Model: Martini-C1/Bellini-C2 Finisher (SR840)	Date: 27-Feb-03	No.: MB478001a
---	-----------------	----------------

Modified Article: Main Control Board and EPROM		Prepared by: K. Miura	
From: Technical Services Sec. Service Planning Dept.			
Reason for Modification:	<input type="checkbox"/> Parts catalog correction	<input type="checkbox"/> Vendor change	<input type="checkbox"/> To meet standards ()
	<input type="checkbox"/> To facilitate assembly	<input checked="" type="checkbox"/> To improve reliability	
	<input type="checkbox"/> Part standardization	<input type="checkbox"/> Other

The Main control EPROM and Main Control Board have been changed as follows:

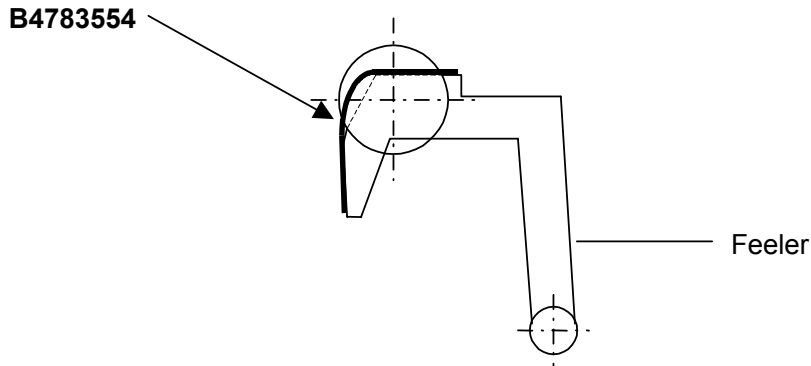
A Guide Mylar has been added to the sensor feeler to ensure the trailing edge of the paper does not get caught on the feeler.

Old part number	New part number	Description	Q'ty	Int	Page	Index	Note
-	B4783554	Guide:Feeler:Paper Sensor	1	-	37	*36

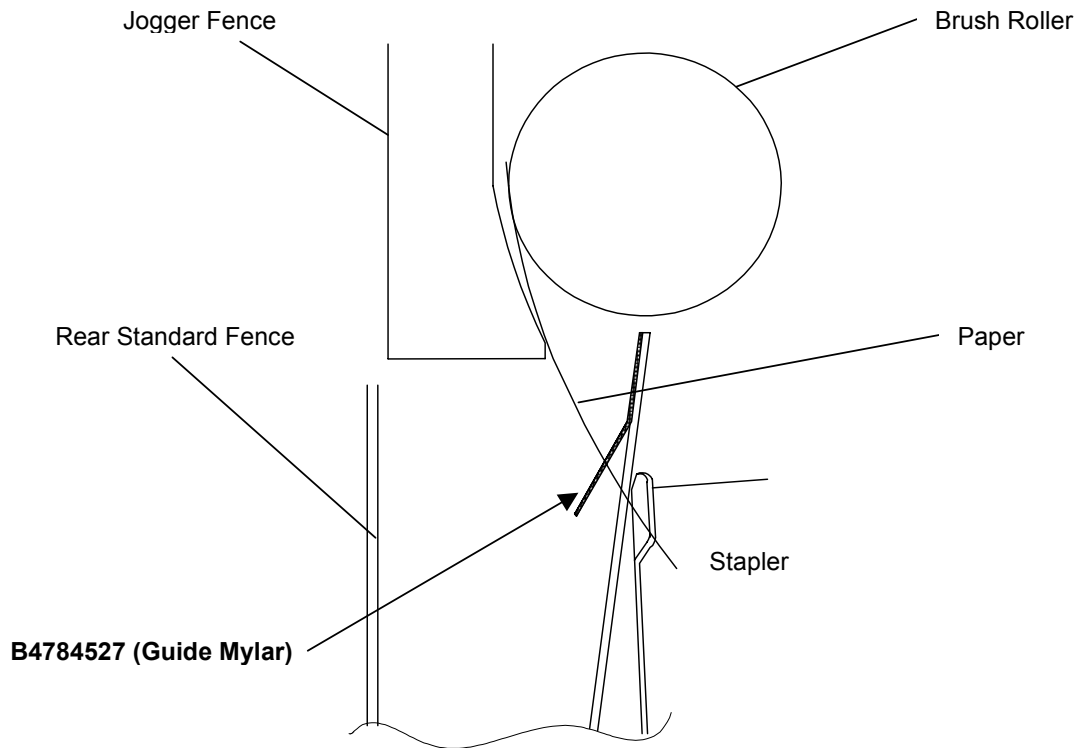
A Guide Mylar has been added to the rear standard fence to ensure that paper in the stapler tray does not skew and cause a stapling error.

Old part number	New part number	Description	Q'ty	Int	Page	Index	Note
-	B4784527	GUIDE:PAPER:INNER BACK	1	-	13	*27

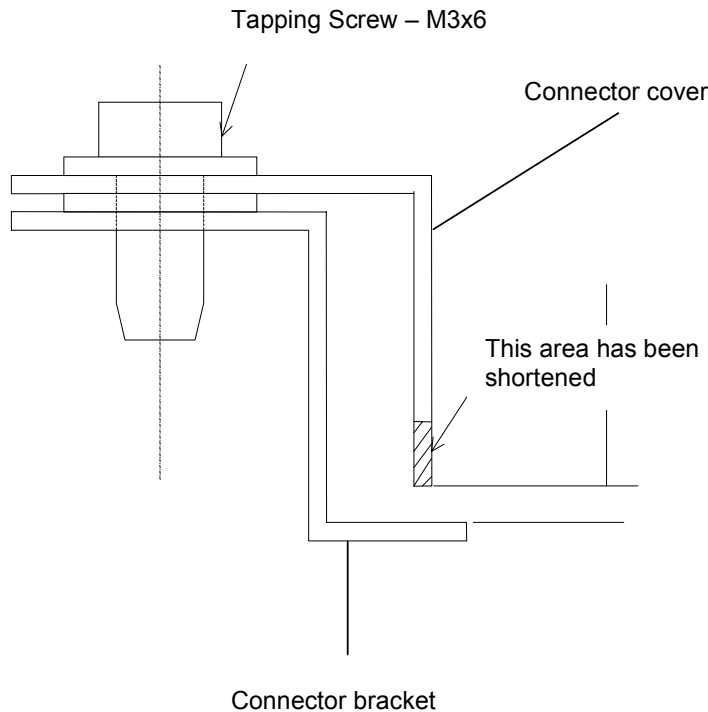
The shapes of the following have been changed to increase the gap between the bracket below and the Stapler Base Slider, in order to ensure that these two parts do not contact each other and generate noise.

Old part number	New part number	Description	Q'ty	Int	Page	Index	Note
AW020086		Photointerruptor	3-2	X/O	15	22	*1
	AW020114		0-1				
B3024298	B3024297	Bracket – Return Support Sensor	1	X/O	15	28	*1

***1: These parts should be replaced together as a set.**
